ADDENDUM NO. 2

April 7, 2022

COLONEL JOHN WHEELER MIDDLES SCHOOL ADDITION, RENOVATION, AND RELATED WORK
Crown Point, IN 46307

SHEET
C-1.1

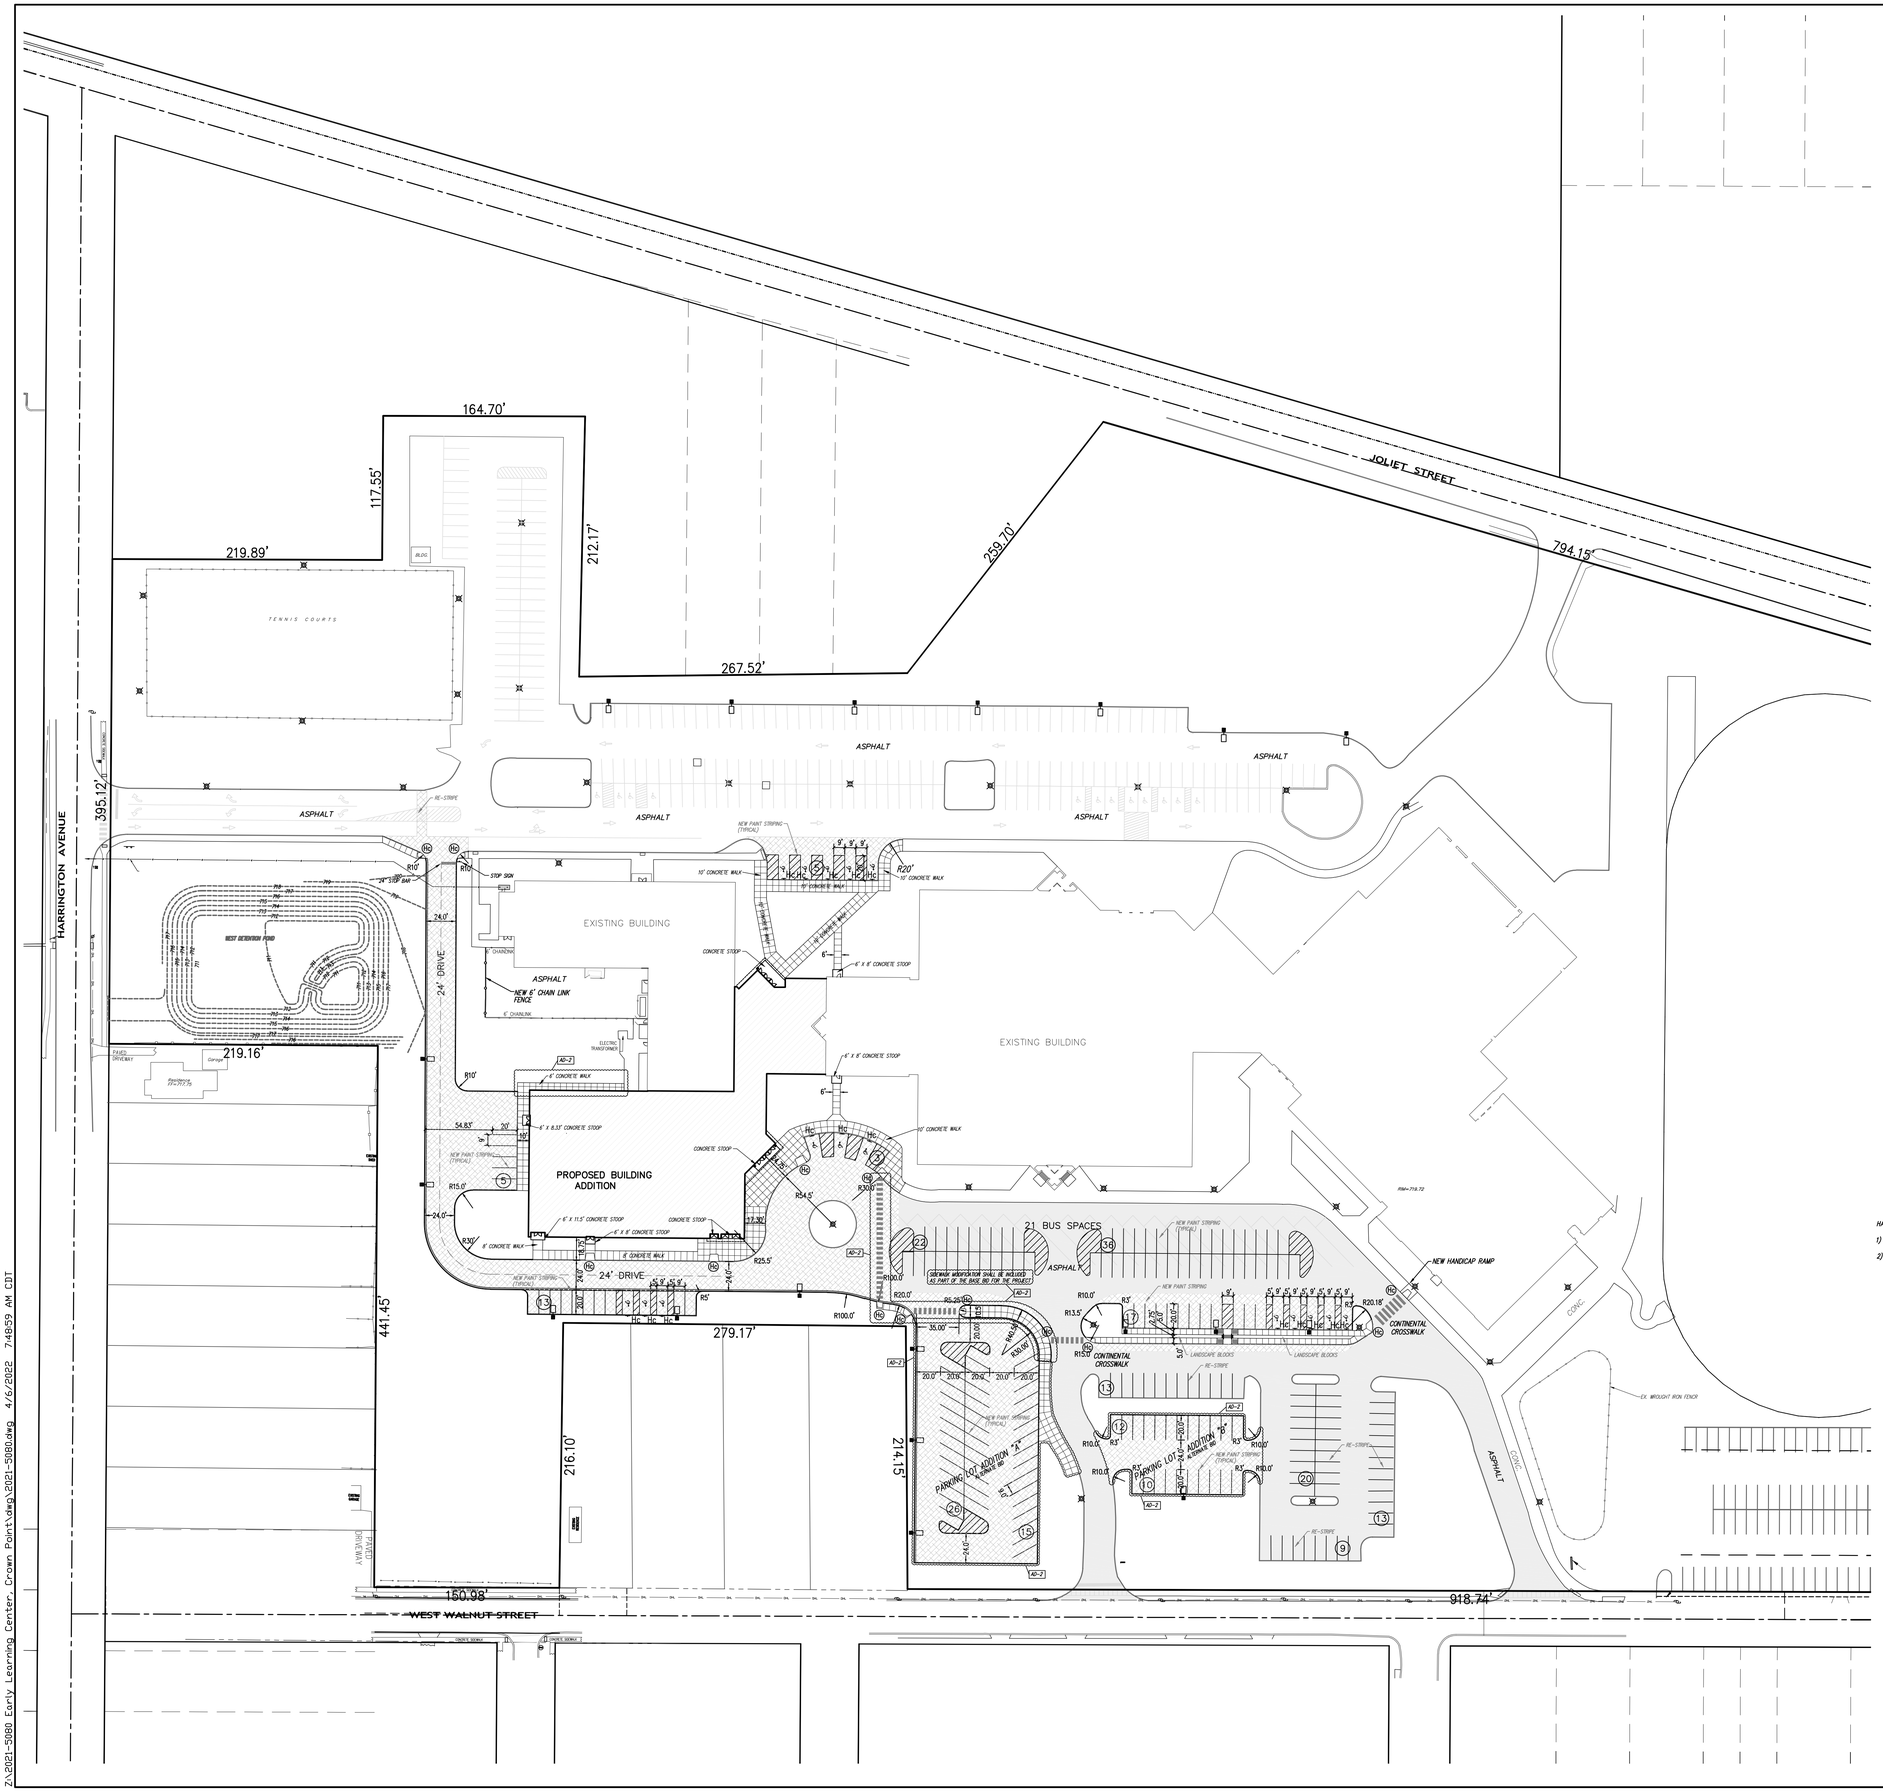
8. Sheet C-1.1

A. Refer to revised, full-size drawing, included in this Addendum, for the following revisions:

SHEET
C-2.0

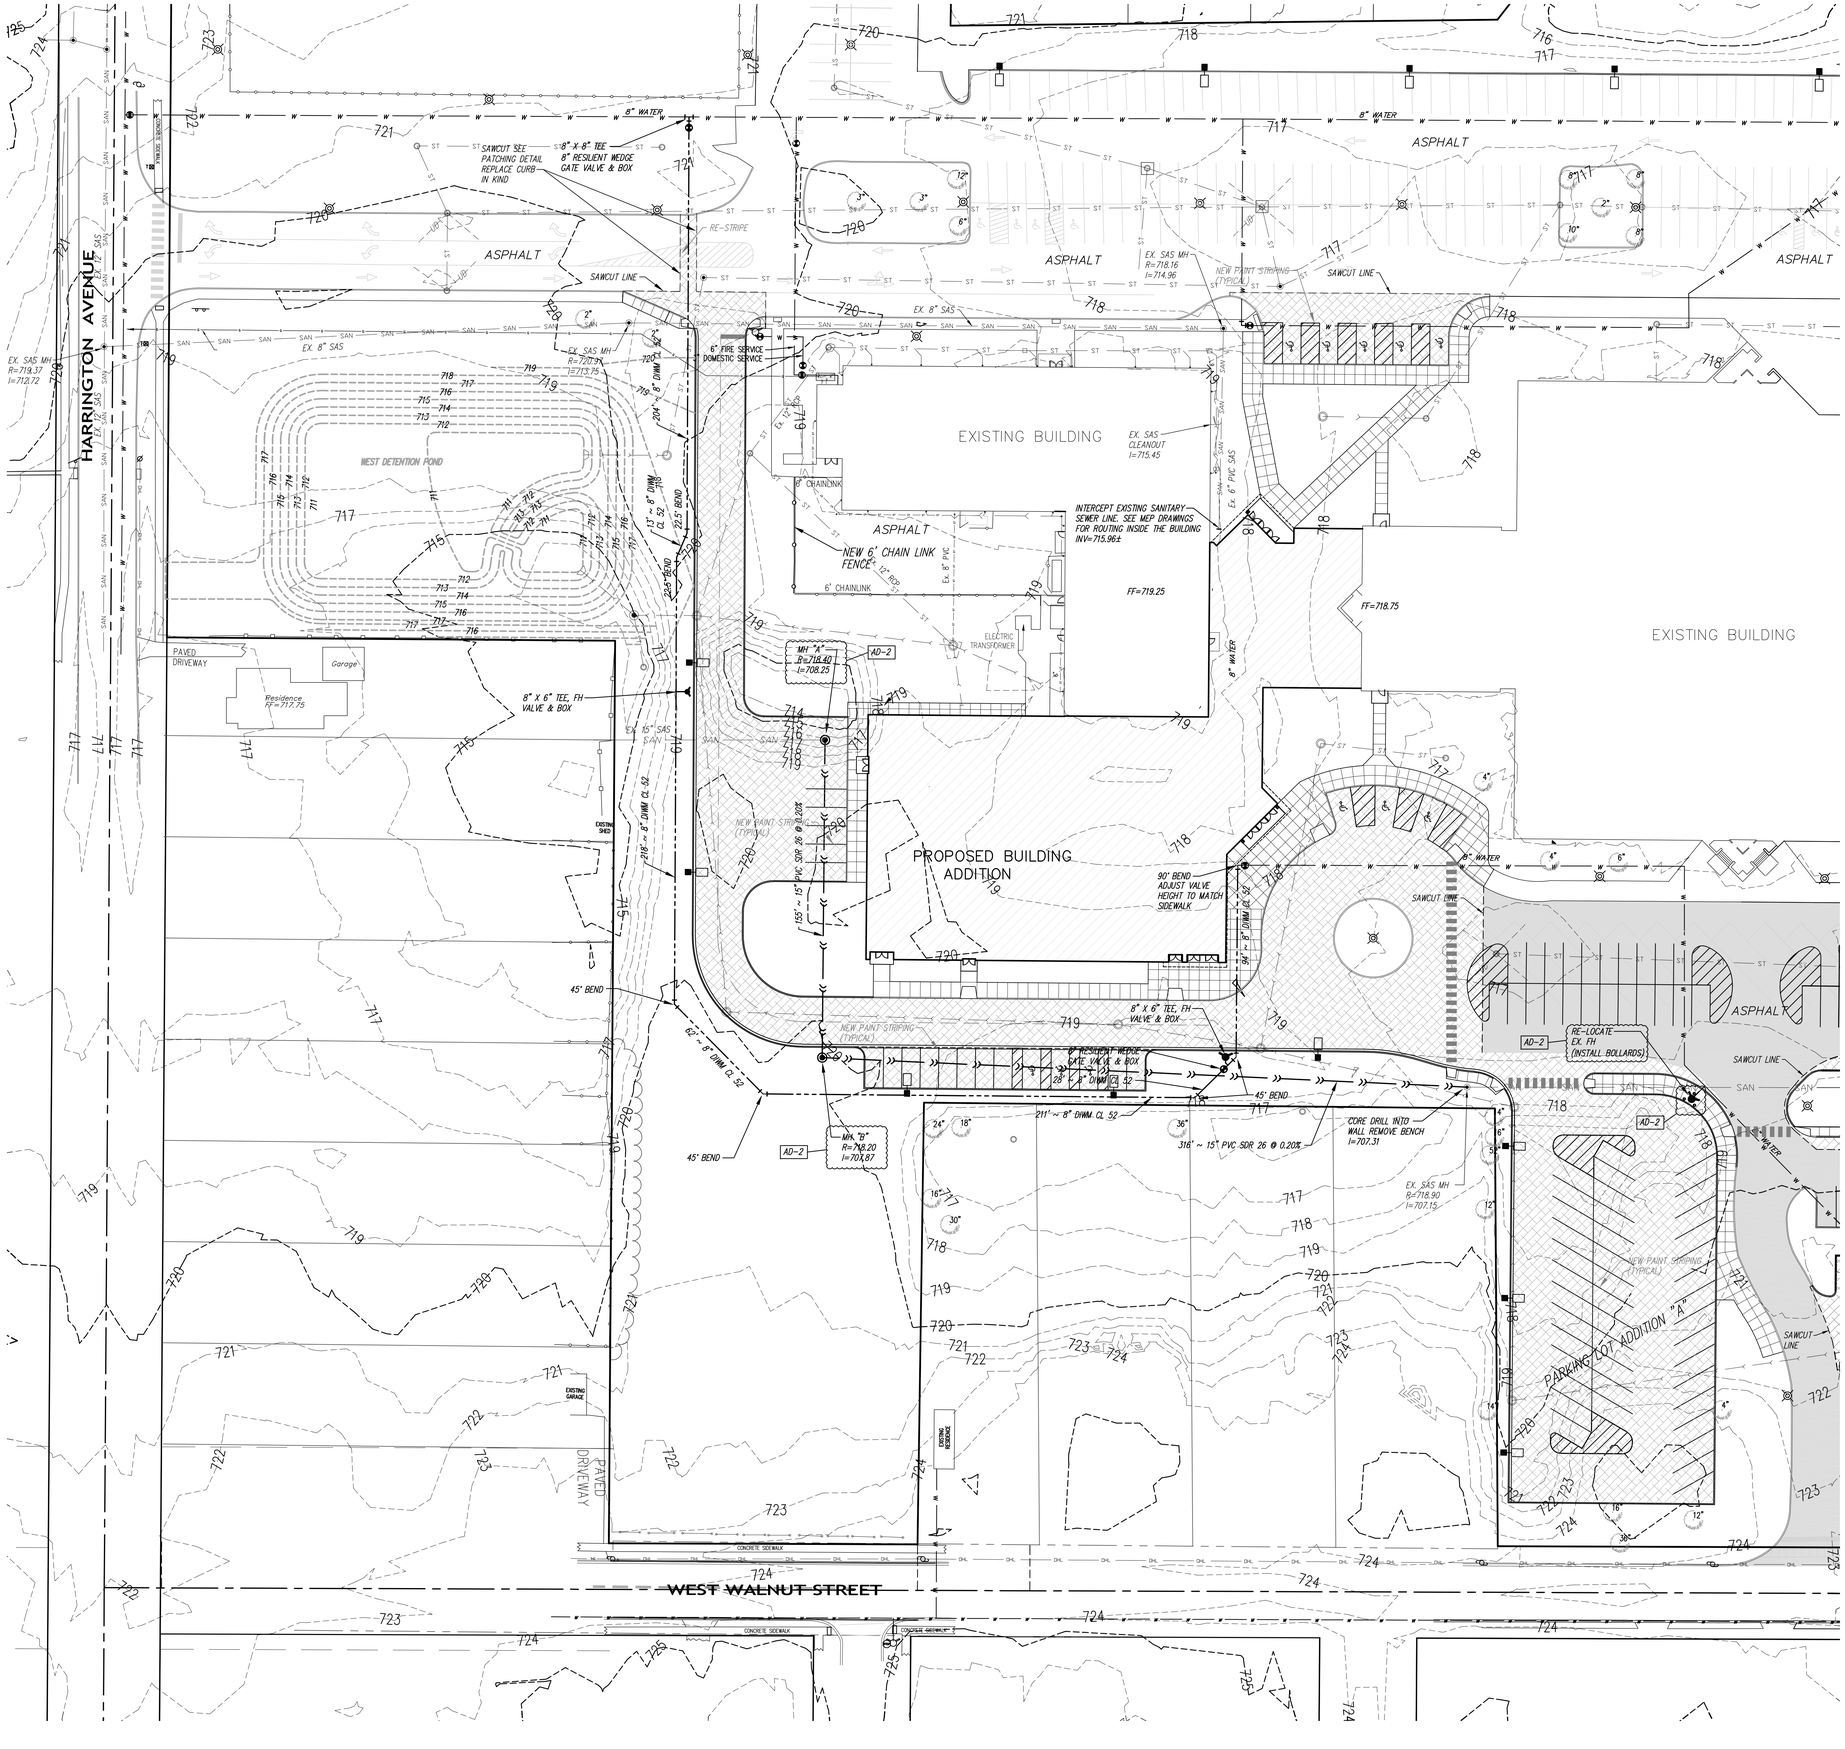
1. The site plan has been modified to included additional sidewalk extension, three handicap ramps, heavy-duty asphalt pavement and continental crosswalk striping.
2. A new 6-foot sidewalk has been added to the north side of the proposed addition. This is part of the Base Bid. Parking Lot "A" and Parking Lot "B" are to be included in Alternate Bid #1.

SHEET
C-3.0

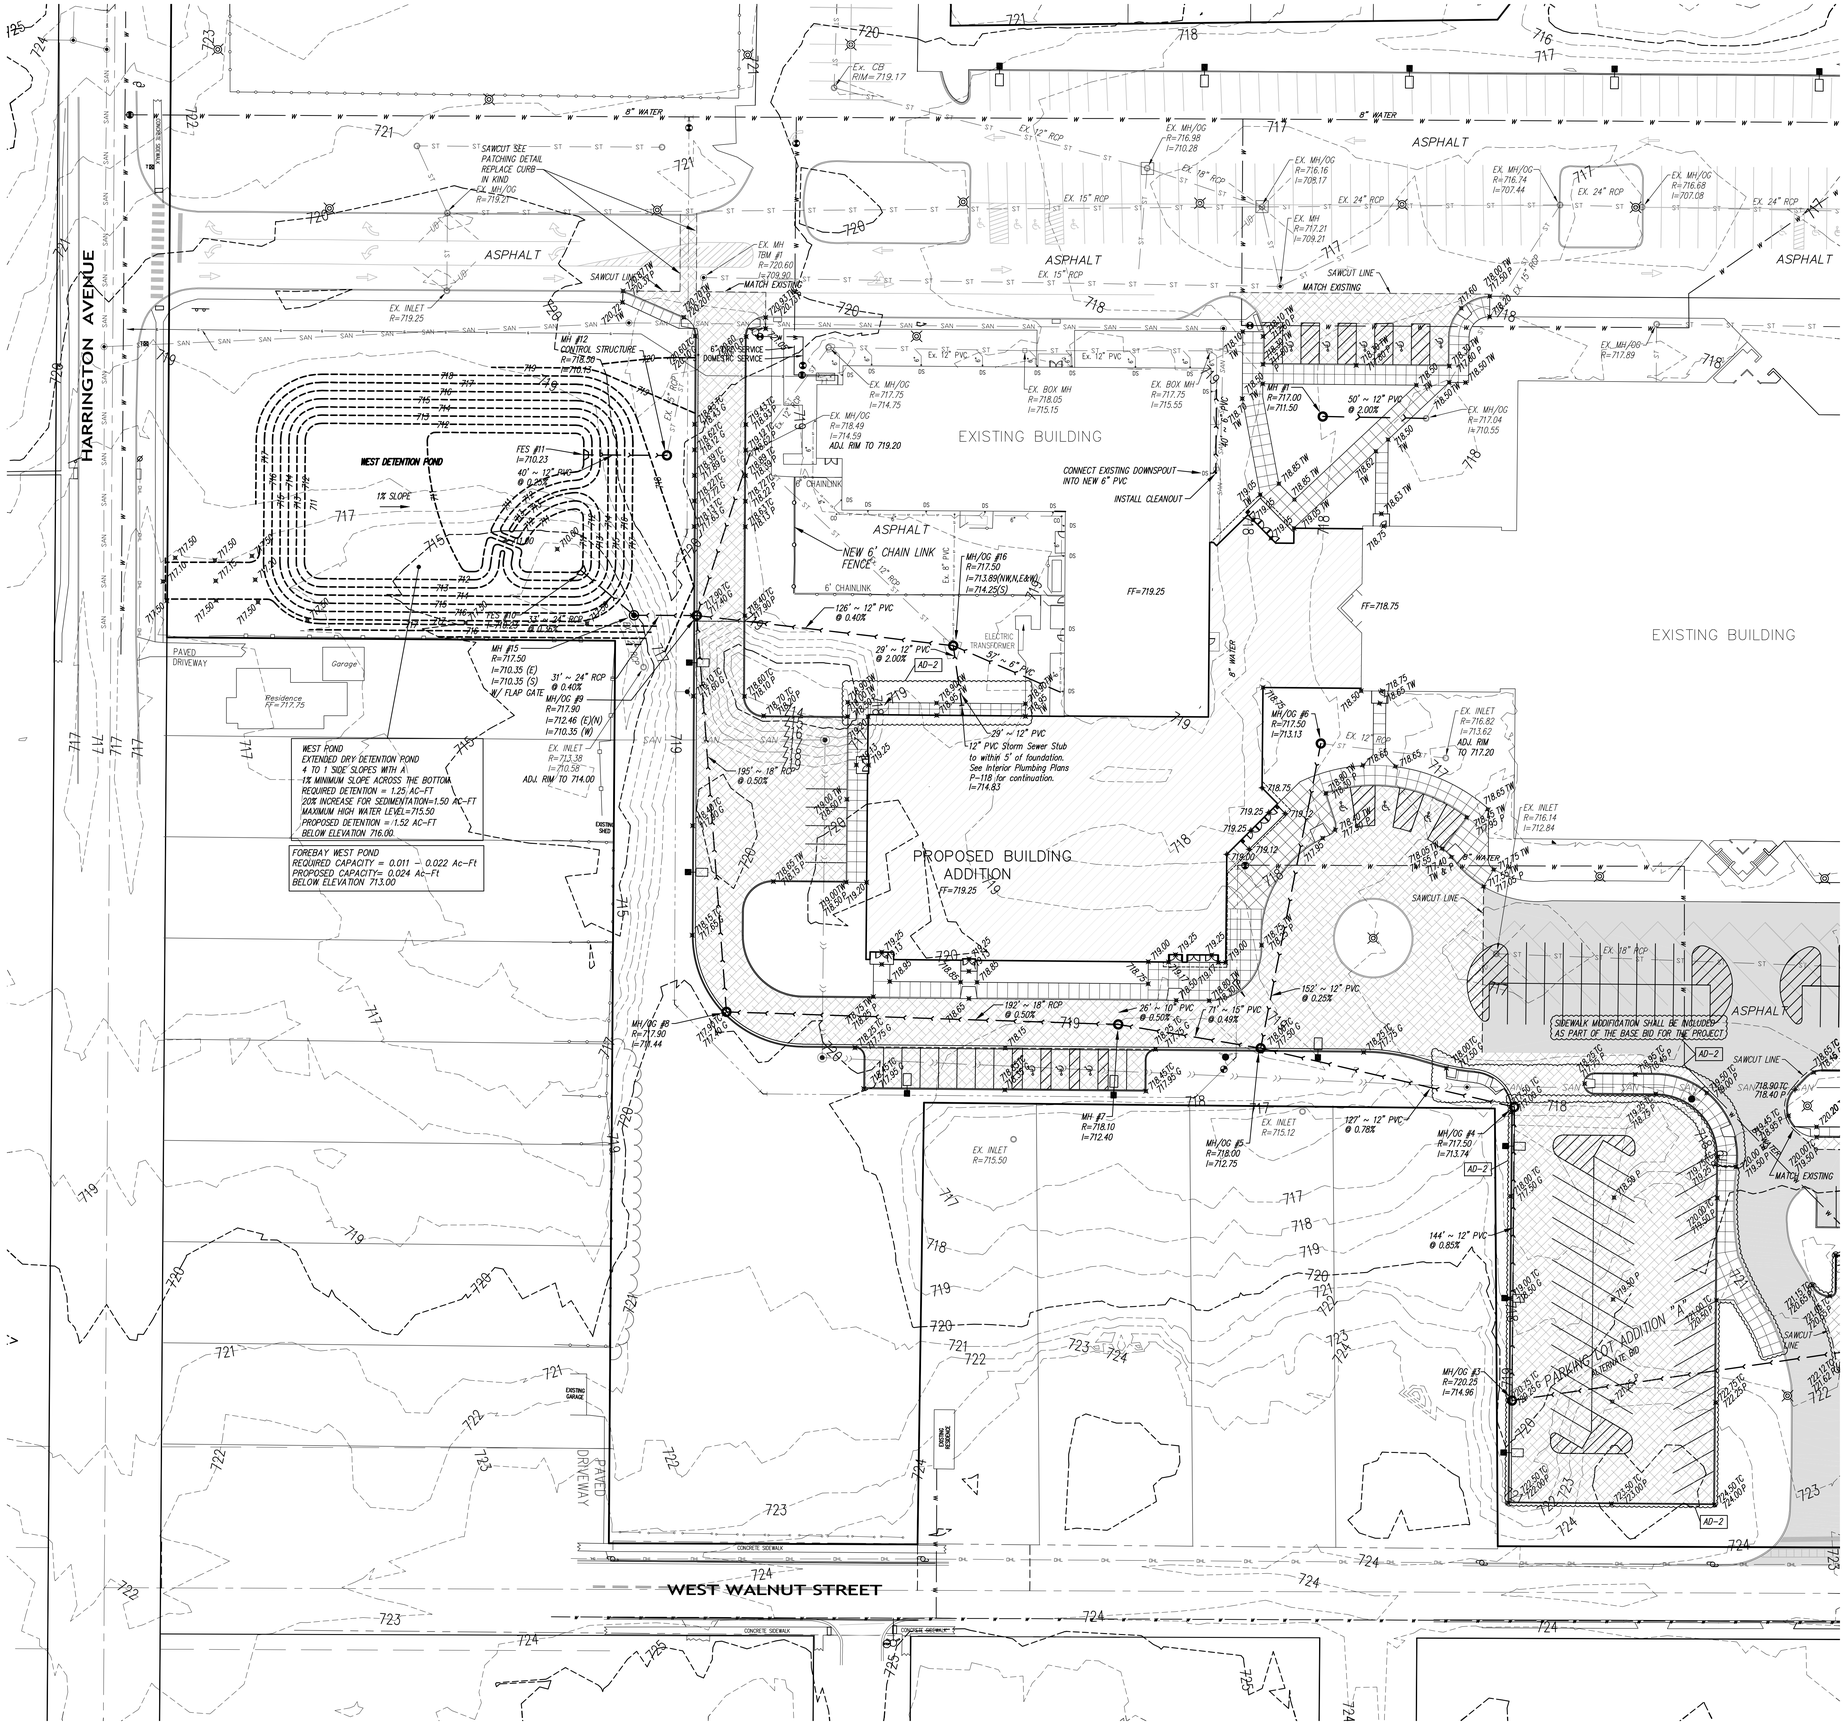
1. The rim elevations for Sanitary Manhole "A" and mismarked Sanitary Manhole "B" have been added. The proposal relocation of the fire hydrant in the new sidewalk extension includes bollard protection. This is part of the Base Bid.
